## Product Change Notification / NTDO-28PSRS829

CCB 4681 Initial Notice: Qualification of STAR as an additional assembly site for selected Micrel products available in 6L VDFN (7x5x0.9 mm) package.

**CCB 4681**  
**Pre and Post Change Summary**  
**PCN #: NTDO-28PSRS829**

**Qualification of STAR as an additional assembly site for selected Micrel products available in 6L VDFN (7x5x0.9 mm) package.**

## NSEB

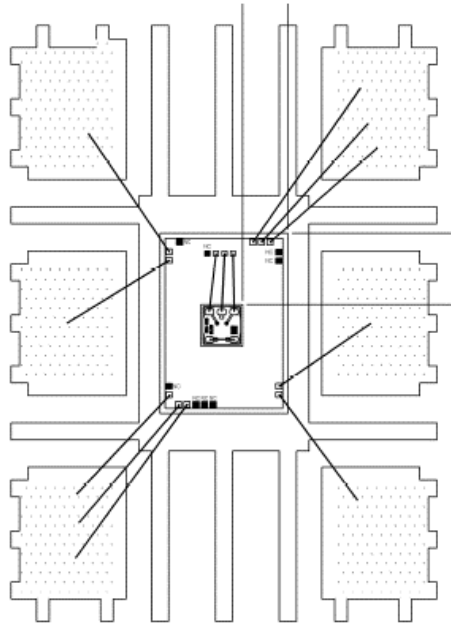
# LEAD FRAME COMPARISON

<b>Leadframe Material</b>	A194
<b>Lead Lock (Locking Hole)</b>	Yes
<b>Lead Plating</b>	NiPdAu

## STAR

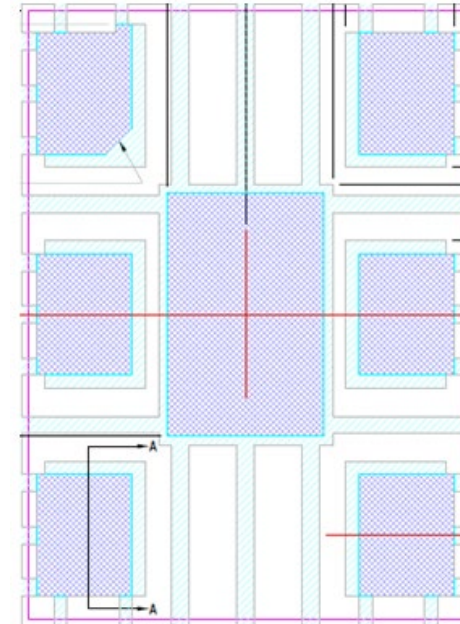
<b>Leadframe Material</b>	C194
<b>Lead Lock (Locking Hole)</b>	Yes
<b>Lead Plating</b>	NiPdAu

**Note:** The lead lock hole fills with mold compound during the assembly process and provides improved protection against moisture penetration around the interface edges between pins and mold compound.
